Access Compliance Report

Public Rights-of-Way

Intersection ID: 24190	Main Street: CANDLEWYCK_LN	Cross Street: LAWTON BLUFF RD	Location: NW
ADA ID: 4D89F366BD88	Ramp Type: PerpDiag	Initial Pass/Fail: Fail	Overall Compliance: No
Severity Score: 12.5			
Codes/Mitigation Info/Possible Solution		Field Measurements/Component Compliance

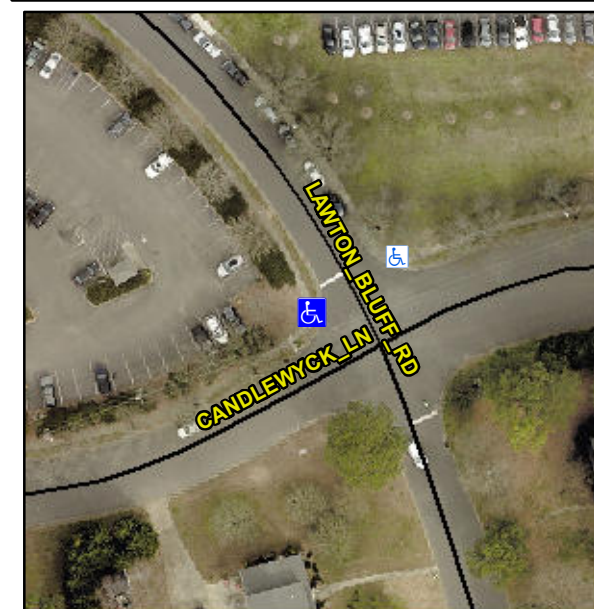
R304.5.3

Compliance	Description	Data	Compliance	Description	Data
N/A	Ramp Length (in)	48.0	Yes	Ramp Slope (%)	5.0
Yes	Ramp Width (in)	48.0	No	Ramp XSlope (%)	5.2
N/A	Flare Type LT	N/A	N/A	Flare Type RT	N/A
N/A	Flare Slope LT (%)	N/A	N/A	Flare Slope RT (%)	N/A
N/A	Flare Traversable LT?	N/A	N/A	Flare Traversable RT?	N/A
N/A	Landing Length (in)	N/A	N/A	DWS Provided?	N/A
N/A	Landing Width (in)	N/A	N/A	DWS Contrast?	N/A
N/A	Landing Slope (%)	N/A	N/A	DWS Length (in)	N/A
N/A	Landing X Slope (%)	N/A	N/A	DWS Full Width?	N/A
N/A	Landing Curb? (Y/N)	N/A	N/A	DWS Offset (in)	N/A
N/A	Shared Landing?	N/A			
N/A	Gutter Ponding?	Yes	N/A	Gutter Slope (%)	N/A
N/A	Gutter Lip Ht (in)	N/A	N/A	Gutter X Slope (%)	N/A
N/A	Painted X Walk1?	No	N/A	Painted X Walk2?	No
	X Walk 1 Direction	To S		X Walk 2 Direction	To NE
N/A	X Walk 1 Width (in)	N/A	N/A	X Walk 2 Width (in)	N/A
	X Walk 1 Slope (%)	4.2		X Walk 2 Slope (%)	0.9
	X Walk 1 X Slope (%)	0.8		X Walk 2 X Slope (%)	3.0

Remove & Replace Curb Ramp With Two New Directional Ramps or Equivalent.
